Access Compliance Report

Public Rights-of-Way

Intersection ID: 27200	Main Street: ANNALEXA_LN	Cross Street: BALLANTYNE_COMMONS_PY	Location: SE
ADA ID: C700697FEDAC	Ramp Type: Perp	Initial Pass/Fail: Fail	Overall Compliance: No
Severity Score: 21.25			
Codes/Mitigation Info/Possible Solution		Field Measurements/Component Compliance

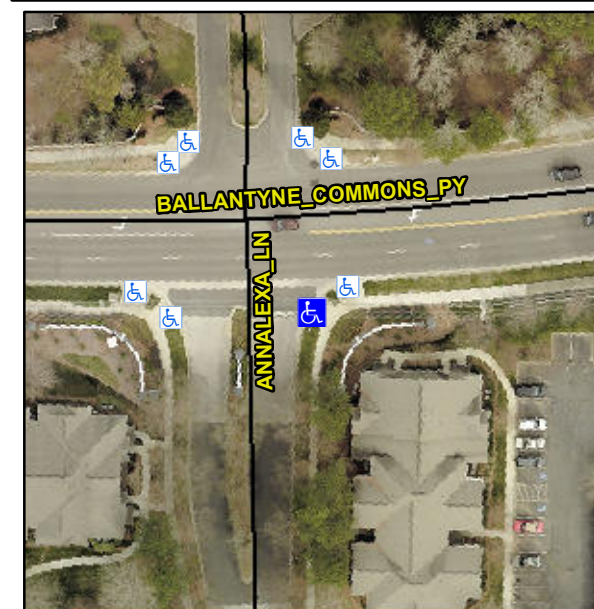
R304.5.1, R304.5.3

Compliance	Description	Data	Compliance	Description	Data
N/A	Ramp Length (in)	96.5	Yes	Ramp Slope (%)	5.7
No	Ramp Width (in)	43.5	No	Ramp XSlope (%)	6.9
N/A	Flare Type LT	N/A	N/A	Flare Type RT	N/A
N/A	Flare Slope LT (%)	N/A	N/A	Flare Slope RT (%)	N/A
N/A	Flare Traversable LT?	N/A	N/A	Flare Traversable RT?	N/A
N/A	Landing Length (in)	N/A	N/A	DWS Provided?	N/A
N/A	Landing Width (in)	N/A	N/A	DWS Contrast?	N/A
N/A	Landing Slope (%)	N/A	N/A	DWS Length (in)	N/A
N/A	Landing X Slope (%)	N/A	N/A	DWS Full Width?	N/A
N/A	Landing Curb? (Y/N)	N/A	N/A	DWS Offset (in)	N/A
N/A	Shared Landing?	N/A			
N/A	Gutter Ponding?	N/A	N/A	Gutter Slope (%)	N/A
N/A	Gutter Lip Ht (in)	N/A	N/A	Gutter X Slope (%)	N/A
N/A	Painted X Walk1?	No	N/A	Painted X Walk2?	N/A
	X Walk 1 Direction	To NW		X Walk 2 Direction	N/A
N/A	X Walk 1 Width (in)	N/A	N/A	X Walk 2 Width (in)	N/A
	X Walk 1 Slope (%)	1.3		X Walk 2 Slope (%)	N/A
	X Walk 1 X Slope (%)	4.3		X Walk 2 X Slope (%)	N/A

Remove & Replace Entire Ramp.
